HYDROGEOLOGICAL REVIEW

HYDE PARK LANDFILL

SUMMONS AND AGREEMENT

ENVIRONMENT CANADA

SCHEMATIC CROSS SECTION SHOWING
GROUND WATER FLOW BETWEEN CONDUITS AND
THE NIAGARA GORGE

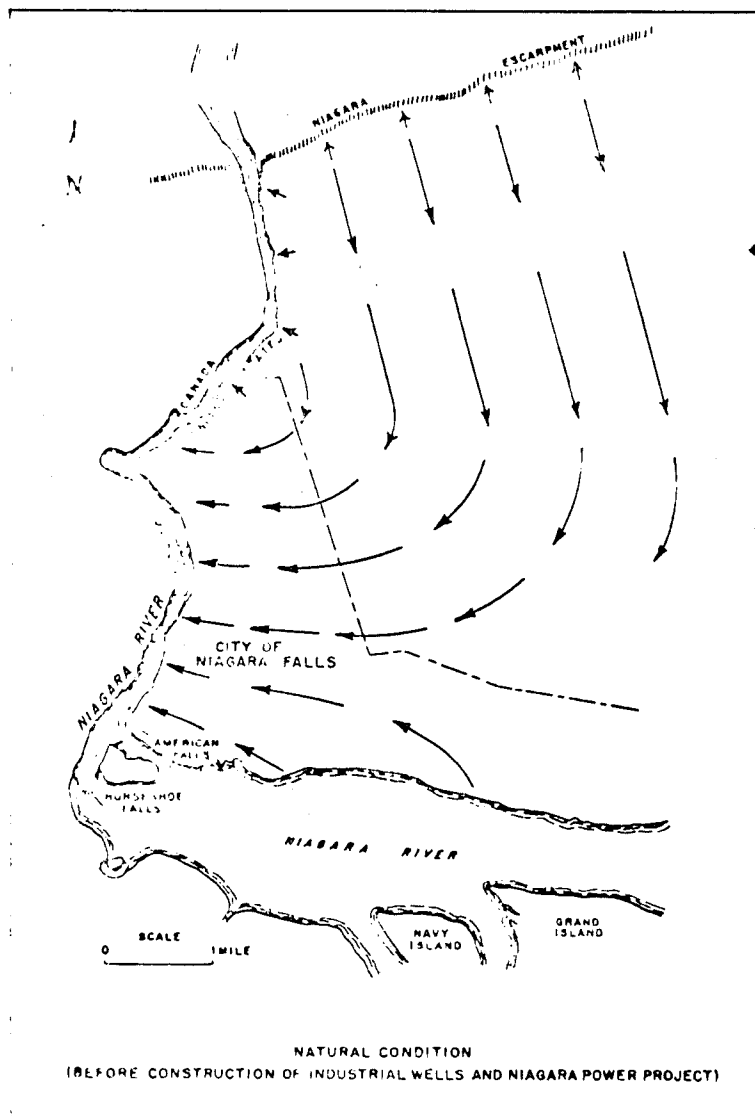
No quantitative analysis of ground water flow was available in the information packet accompanying the agreement. However, preliminary calculations can be carried out once one has a basic understanding of flow directions. According to the agreement, ground water flows to the north west (page 5) towards the Niagara Gorge in the bedrock. No technical data supports this flow direction. In fact, data indicates that the landfill is, in fact, located in a ground water recharge area with flow (in the shallow bedrock zone at least) moving westerly,

northerly and easterly away from the site. These radial flow directions are influenced by the Niagara Gorge to the west, the twin buried conduits to the east and the open canal to the north. (See Figure 14, page 54 in Ground Water in the Niagara Falls Area, New York by R.H. Johnston). The location of the landfill has been imposed onto the "Present Condition" of the figure. If a cross section were drawn between the Niagara Gorge, through the site and to the Conduit the following condition would exist.

It is apparent that immediately below the site, ground water movement is vertically downwards and radiates both east and west of the site. This is a typical example of a ground water recharge area.

SCHEMATIC OF WATER BUDGET THROUGH WASTE

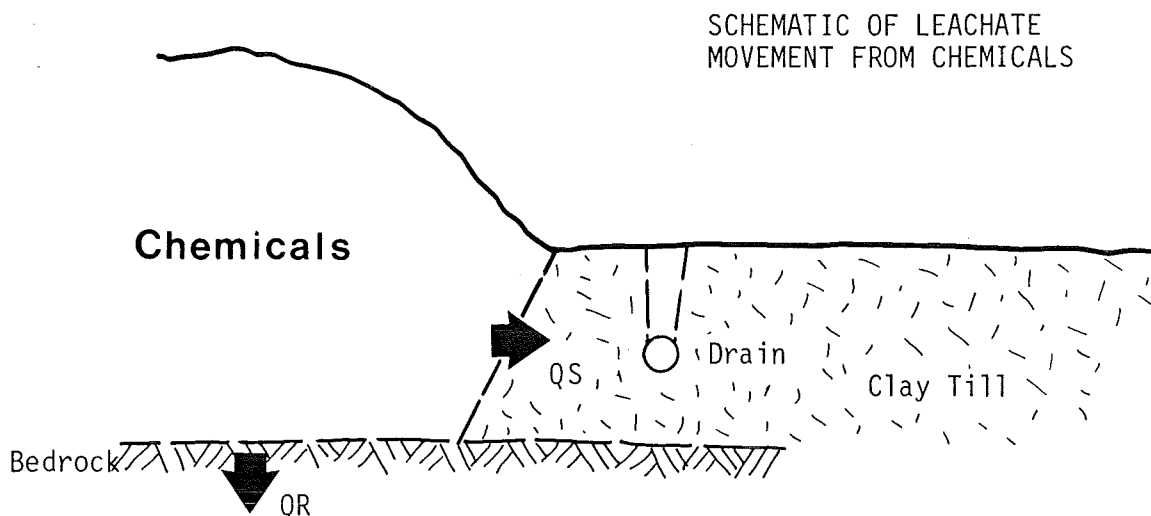
Capping of the landfill is intended to reduce infiltration. If precipitation infiltrates the landfill at a rate less than the ground water outflow through the bottom, then leachate will not mound and come to ground surface. Thus, there would be no need for a toe drain overburden leachate collection system. It is a simple fundamental calculation required to determine this need. The diagram below illustrates the basic components of the calculations.

If $QI > QR$ leachate mounds and comes to surface

QI - the quantity of precipitation infiltration can be determined from the rule of thumb used by hydrogeologists. That is 12 inches of infiltration on the average over a year would equate to about 1/2 imperial gallon per minute (IGPM) per acre of fill on the average. Capping should reduce infiltration to less than 6" of precipitation or about 0.25 IGPM per acre.

changing the units and substituting into the equation, $QR = 106 \text{ IGPM/acre}$. It is obvious that the potential leachate outflow will exceed the potential precipitation inflow by a factor of 400 times.

Based on this analysis we can only conclude that the overburden barrier system will not be functional in collecting the most significant component of leachate movement away from this site. It is of paramount importance that the contaminants leaving the bottom of the site be collected as the primary line of defence to ensure that dioxin is not released to the environment.

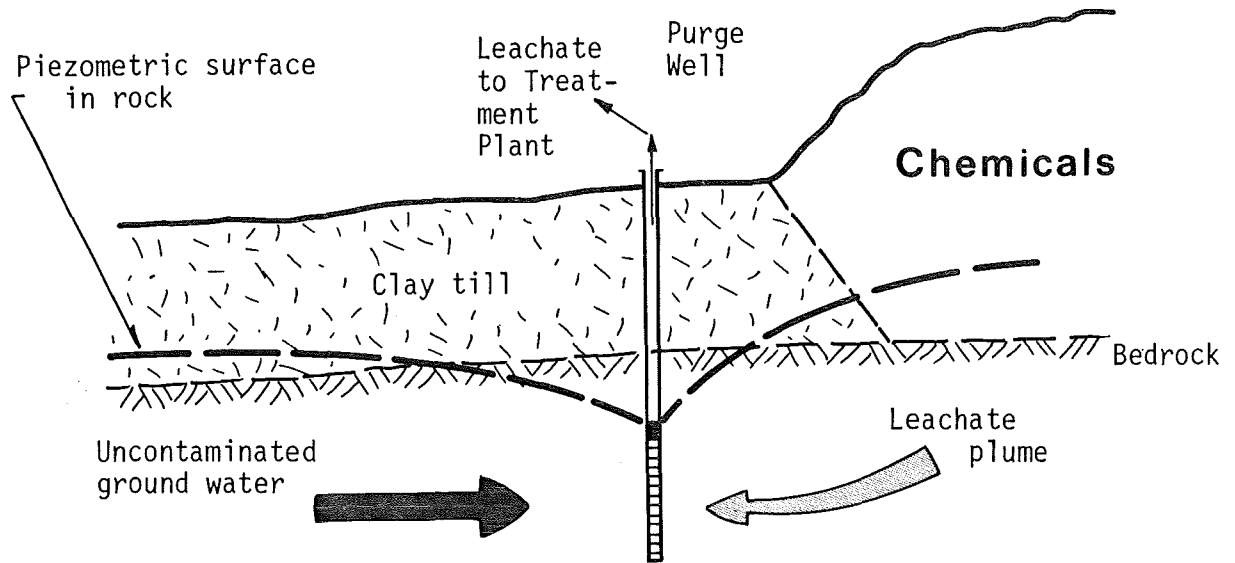
This point can be further emphasized when one considers the fact that the proposed overburden barrier drain is located within natural clay soils outside the fill (see sketch below and Figure 7 in the agreement).

Calculations given in Section 2 of this brief indicate that outflow to the bedrock QR is a minimum of 1000 times greater than flow through the soils (QS). This uses a permeability in the soil of 10^{-7} cm/sec and some simplifying assumptions concerning gradients that give all benefit of doubt to the proponent (Hooker Chemical). In actual fact using realistic gradients it can be shown that outflow through the rock could be as much as 200,000 times greater than flow through the clay till.

It could be argued that the clay is very fractured and 10^{-7} cm/sec is an unreasonable permeability to use in the equations. If we use a permeability for fracture flow of 10^{-4} cm/sec outflow in the rock would still exceed flow to the drain in the overburden by a factor of 200.

It is obvious that the overburden barrier drain system will not prevent the most significant release of contaminants to the environment and that outflow of chemicals to the bedrock is the most critical aspect of contamination requiring remedial action at this site.
